**TOWN OF KINGSTON  
CONSERVATION COMMISSION**

# Memo

**Subject:** Pilgrim Nuclear Power Station Re-Licensing

## **Kingston Water Resource Concerns on Re-licensing of Pilgrim Nuclear Power Station (PNPS)**

# ENVIRONMENTAL SENSITIVITY INDEX MAP

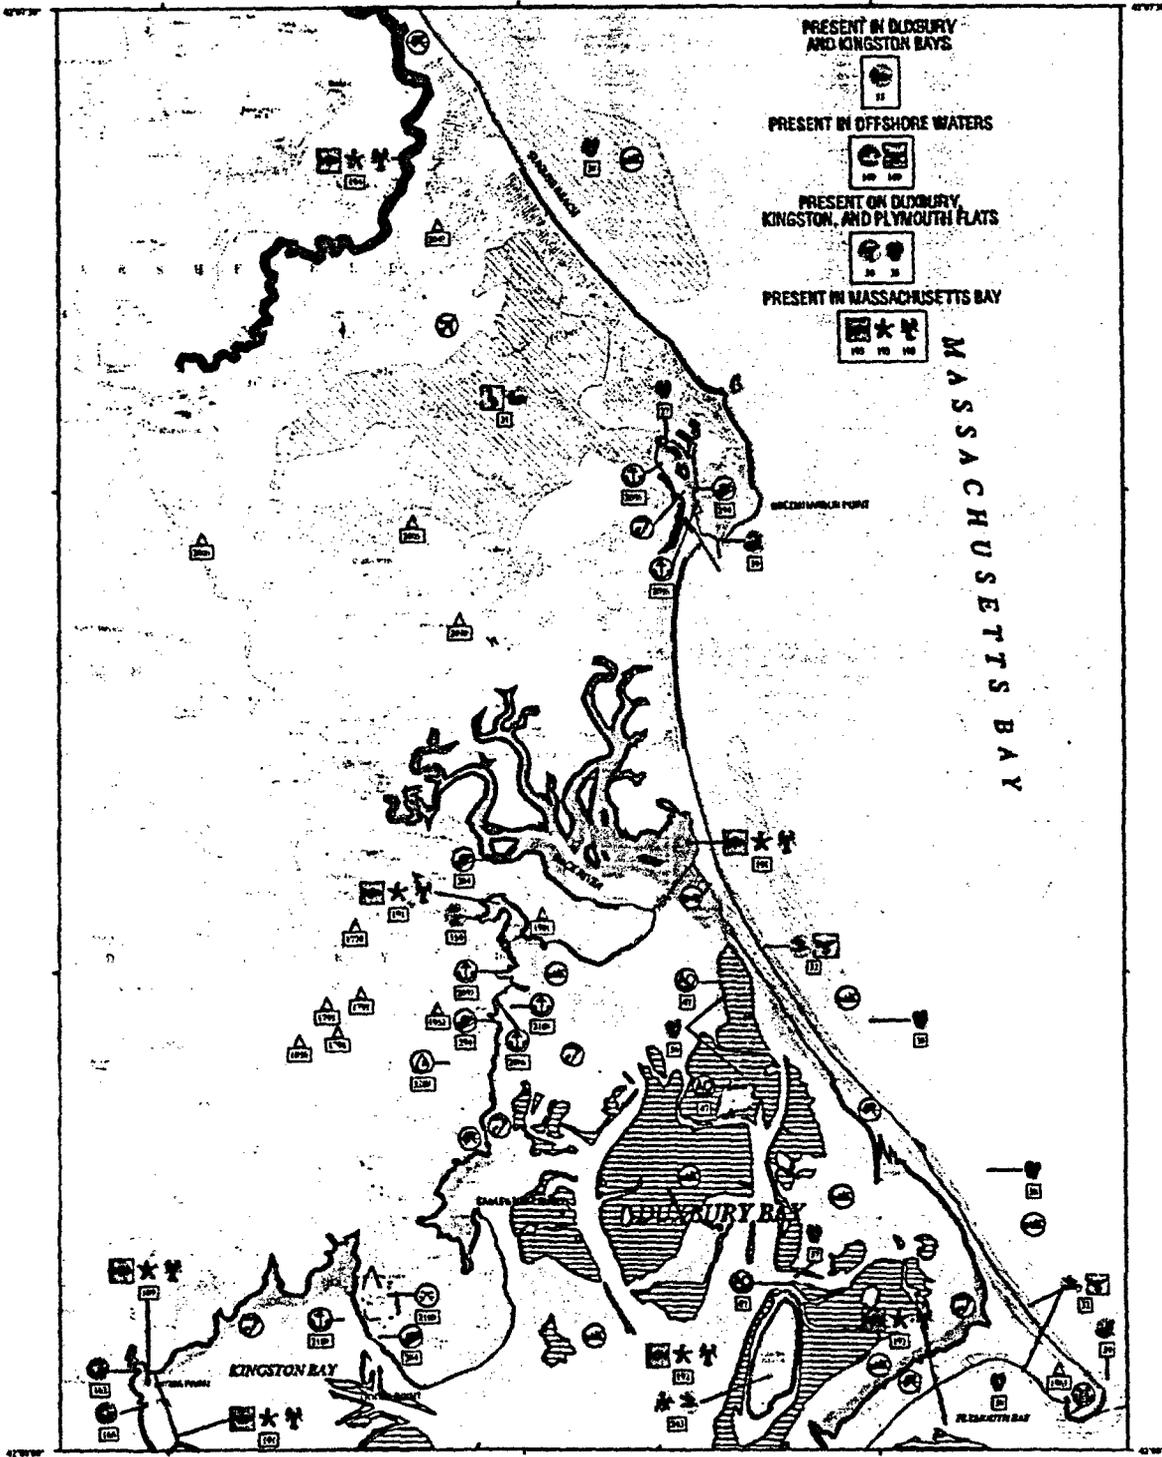
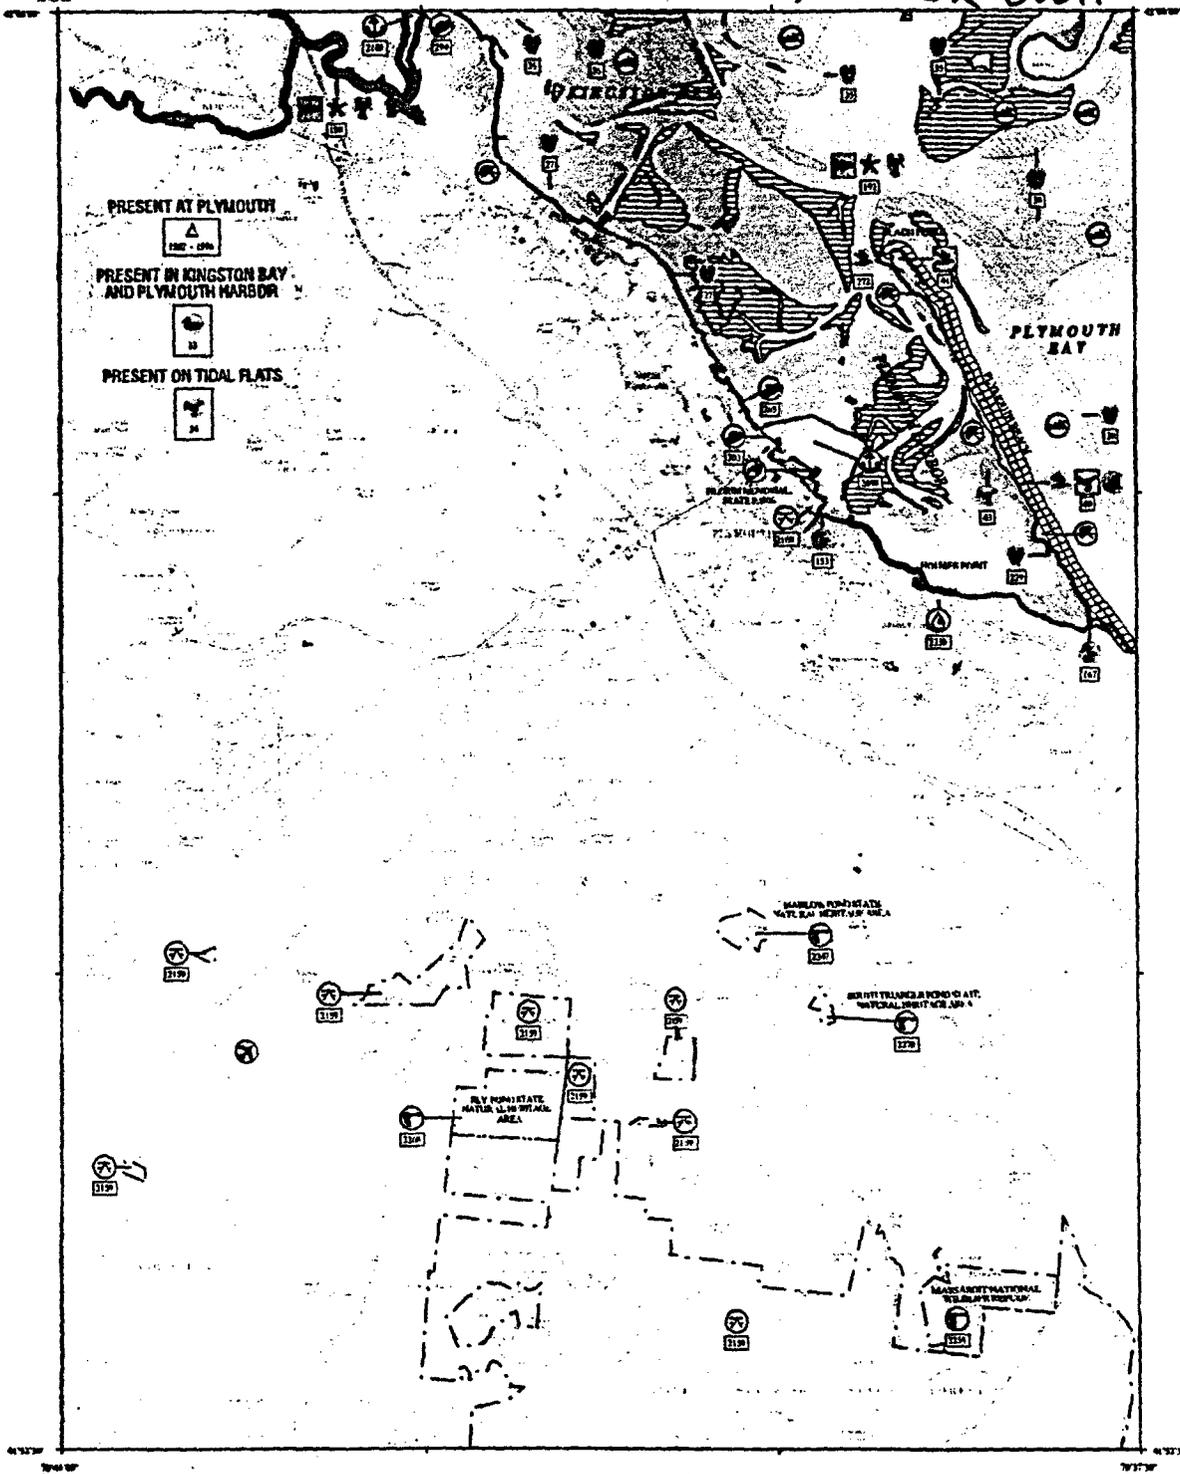
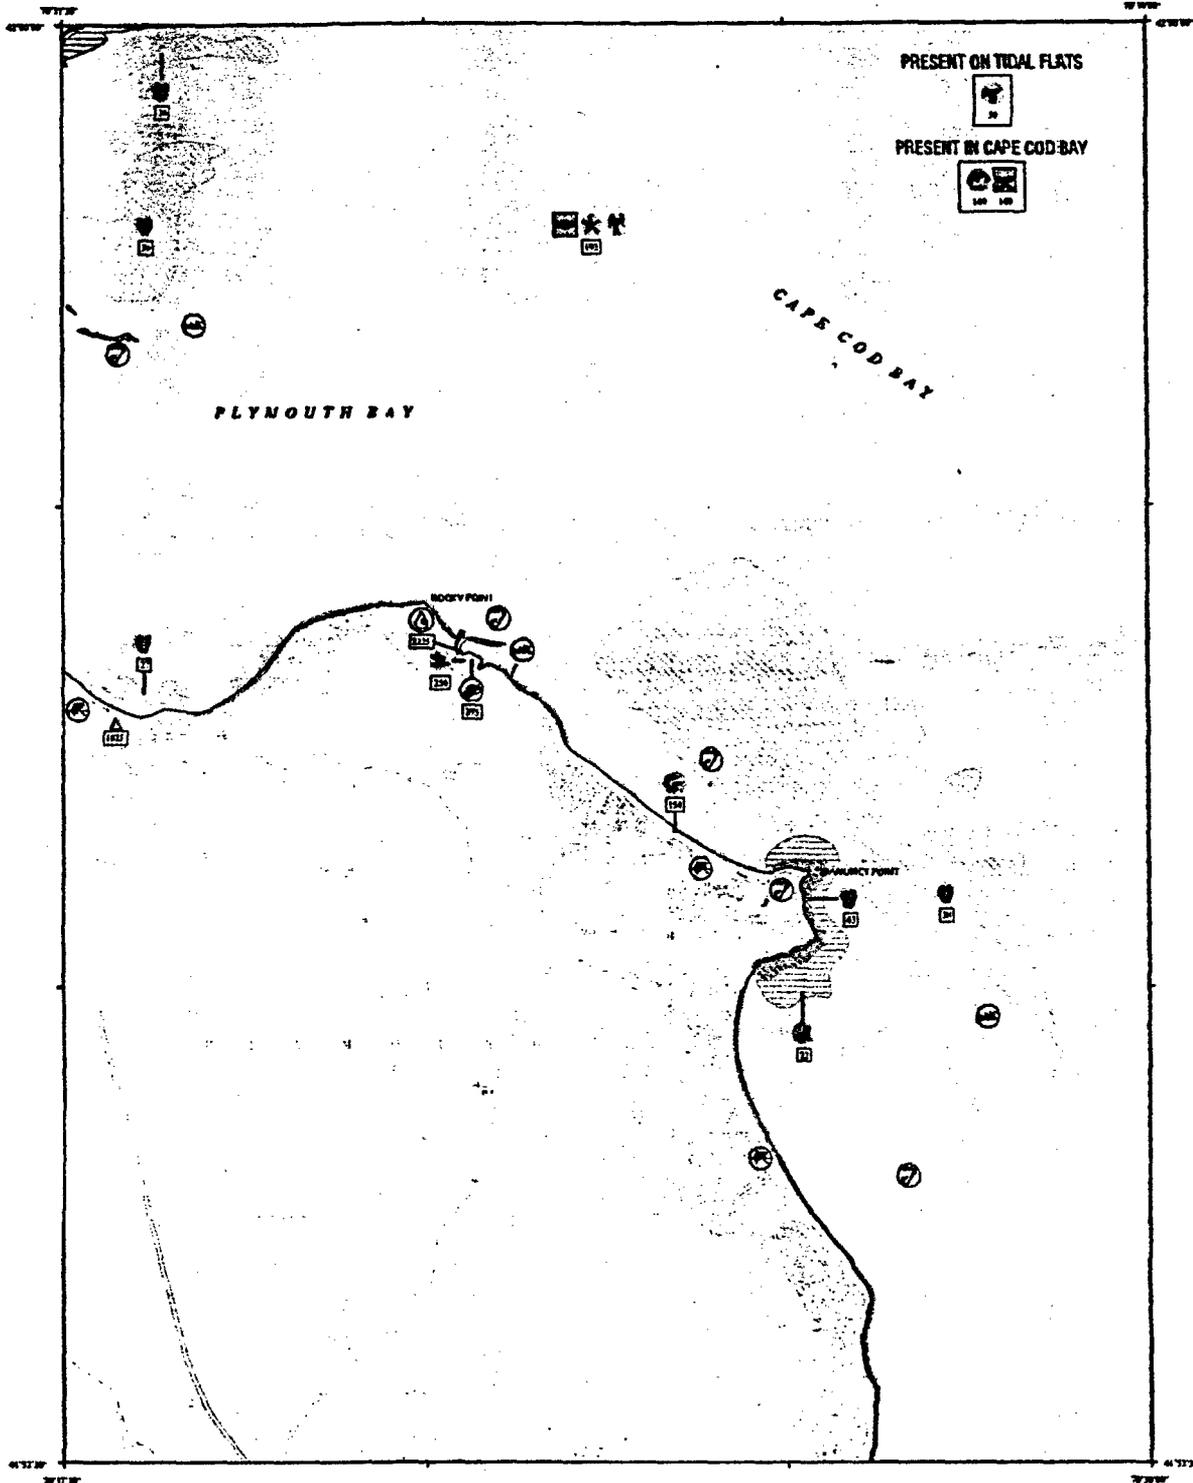
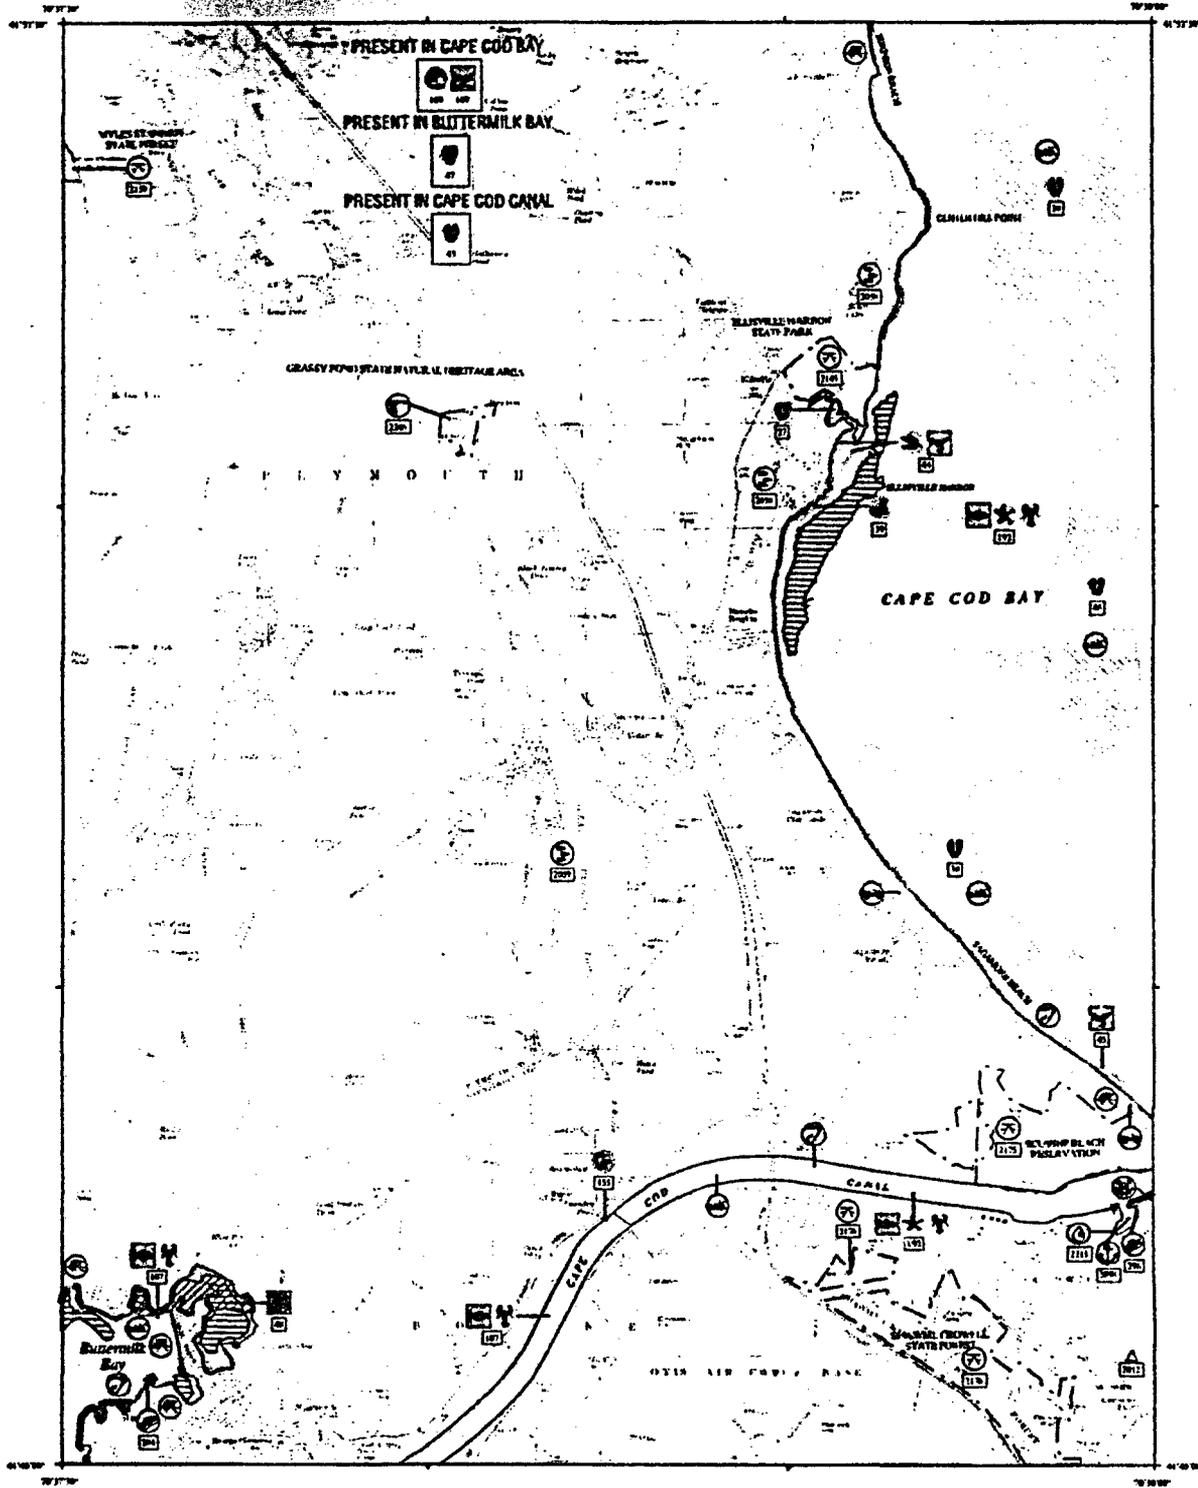
There are also other sensitive resources in the Plymouth-Kingston-Duxbury embayment including one of the most extensive eel grass beds in southeastern Massachusetts and extensive salt marsh systems. These areas are crucial habitat for shellfish and migratory species (See attached Environmental Sensitivity Index and Maps along with the BioMap produced by Natural Heritage and Endangered Species Program (NHESP) for the area). It would be helpful to know if these habitats are harmed in any way as a result of the ongoing once-through cooling system at PNPS.
